R05JS

RECALL R05JS
INSTRUCTIONS FOR REPLACING DASH WARNING LIGHT OVERLAY DECAL

Overlay decal

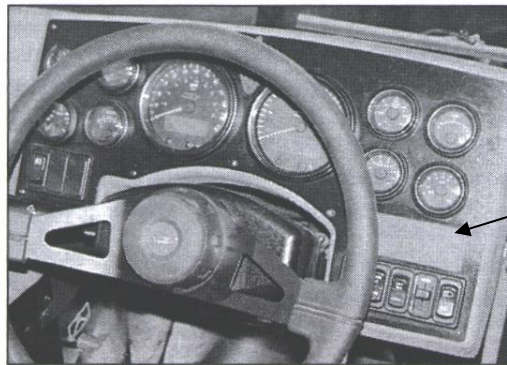
The nonconformance relates to the brake dash warning light indicator. The original dash warning light indicator displays an International symbol on the brake warning light indicator whereas FMVSS 571.105 requires the words "BRAKE PRESSURE" to be displayed. The operator may not recognize the International symbol as warning indicating a problem in the hydraulic brake system which could result in the potential for vehicle crash should the warning not be heeded.

- 1. Locate the 12-position telltale overlay in the lower right side of the instrument panel.**

- 2. Using a sharp object, such as a razor knife, carefully peel one side of the overlay out of the recessed pocket. Take care to avoid damaging the front of the dash panel.**
- 3. Remove and discard the old overlay.**
- 4. Carefully peel the protective backing from the new overlay. Avoid touching the back of the overlay as this may affect the adhesion.**
- 5. Ensure the overlay is right side up by holding it up to the light.**
- 6. Place one side of the overlay into the recessed pocket and lightly press in the rest of overlay until it is evenly located in the recessed pocket.**
- 7. Cycle the dash ignition to ensure the overlay was properly installed.**
- 8. Rub the overlay to ensure it is mounted securely using a clean, soft cloth.**
